**BMP NUMBER:** PC149

Blue Heron Course Holes 1-4 & 14-18

SUBJECT: Case No. S-119-84, Ford's Colony Section II

**Lot 35, Ford's Colony Section 31 (111 Western Gales)**

LOT 34 T.M.(37-2)(11-

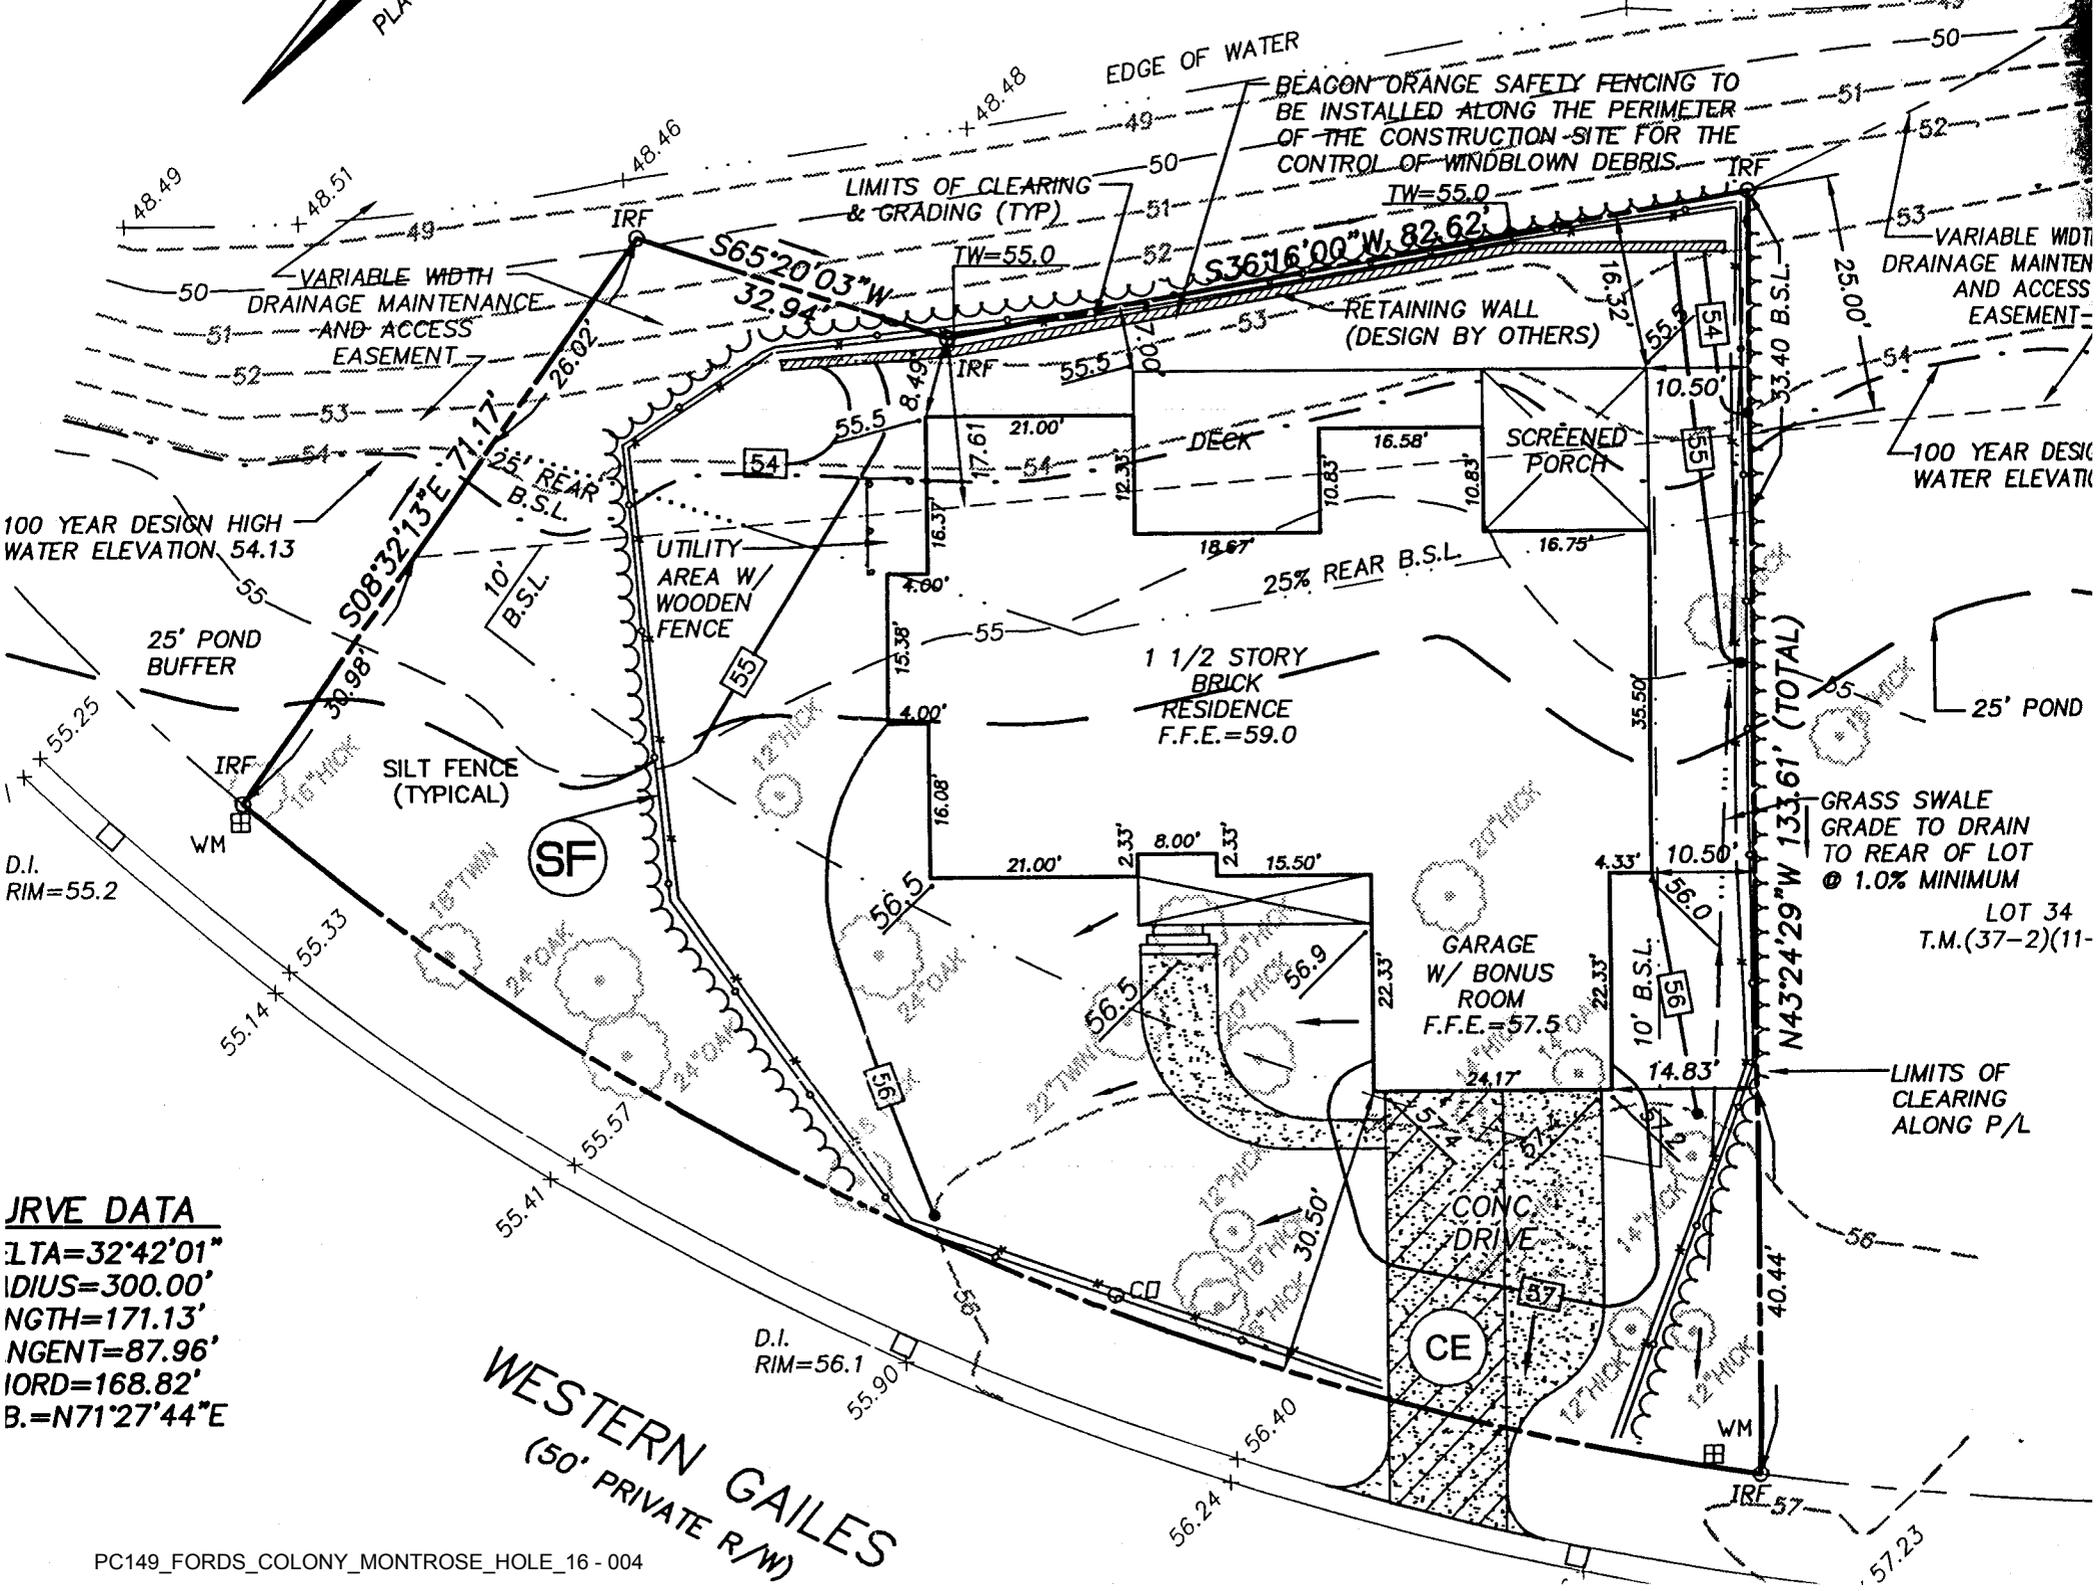
Clearing, grading, filling and permanent structures are shown within the design high water elevation area of the BMP and within the pond setback/buffer as required per page 38 of the James City County BMP manual. A pond buffer should be provided that extends 25 feet outward from the maximum water surface elevation of the pond. Based on information as available in our record files, it appears the 100-year design high water surface elevation for the adjacent dry pond stormwater management facility (BMP # 1, County BMP ID Code: PC 191) is at Elevation 54.13.

Reconfigure the plan to avoid being situated within the pond's design high water elevation and conform with current setback/buffer requirements; or alternatively, submit a written request for waiver to the Environmental Division with supporting information including: correct delineation and labels for the design high water; correct delineation and labels for the 25 ft. pond buffer/setback; proposed horizontal and vertical separations to design high water; an engineering analyses that the proposed lot fill material and placement of the structure will have no adverse impact on the storage volume or function of the stormwater management facility; and the intent for landscaping/restoration of impacted design high water and pond buffer/setback area.

The variance request needs to be from the owner or tenant, current or future, rather than the builder or contractor.

Variance request as submitted by the Owner for clearing, grading, filling and permanent structures in the pond buffer and design high water elevation for the adjacent pond and the engineer's analyses of no effect to the existing BMP (dated February 24, 2005) reviewed and found to be acceptable. Efforts should be made to limit fills in the design high water area to the greatest extent possible and to limit clearing and preserve existing trees and vegetation in the 25 ft. pond buffer/setback and landscape or stabilize impacted design high water area and associated buffer area to resemble meadow or forest area with native trees, shrubs and ground cover to the greatest extent possible.

To provide a baseline, AES researched the design files and identified the 100-year WSEL to be 54.14 ft. According to the current development plan, the grading for the lot will result in altering down to an elevation of 52.5. Our calculations show that the total net loss in volume due to the planned impact will be approximately 2,867 cu. ft., which translates to a change of approximately one and a half percent in the total storage volume of the pond. The change in the WSEL due to the 100-year storm is negligible (less than five hundredths of a foot).

**PLAT OF FORD'S COLONY AT WILLIAMSBURG**  
 SECTION II  
 LOT 153 TO LOT 199  
 POWHATAN DISTRICT JAMES CITY COUNTY VIRGINIA

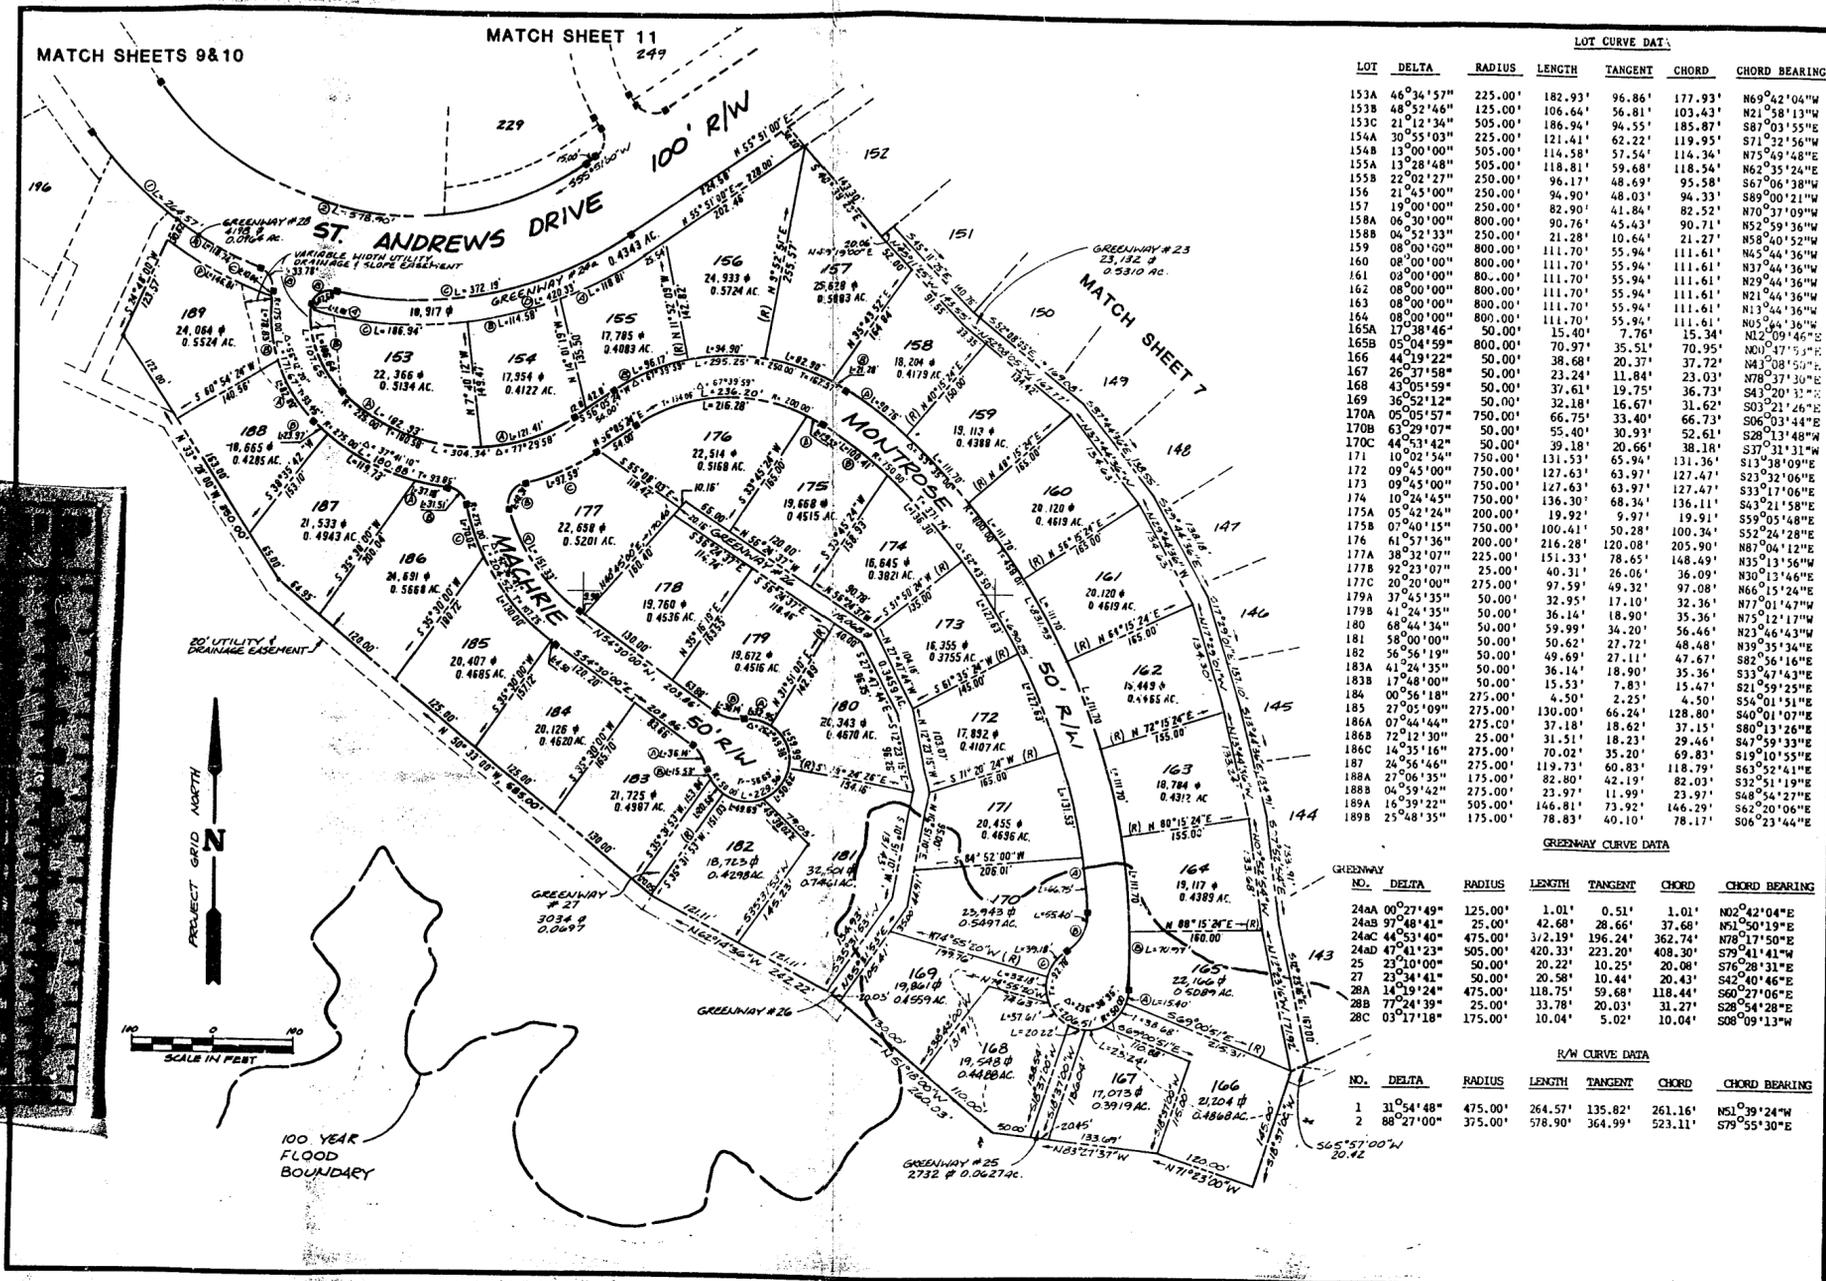
**FIRE DEPT:**  
Street names need to be shown.

- (1) VDHIT requirements for the main entrance at Longhill Road shall be met.
- (2) Street names shall be shown on plans.
- (3) A Land Disturbing Permit shall be submitted to the Department of Public Works.

- (8) A sanitary sewer connection shall be provided to the guard house.
- (9) The engineer shall certify that filling in the flood plain will not increase the elevation of the 100 year flood.

- (10) Manhole #47 shall be lowered to achieve a 4' depth.
- (11) Erosion and sediment control measures shall be shown around the proposed pump station.

(21) The extent of the 100 year flood plain shall be clearly shown on the record plat. The elevation of the finished surface of the ground at each building location shall be shown.

(22) Road H, C, D shall be realigned or the space between the intersections shall be increased.
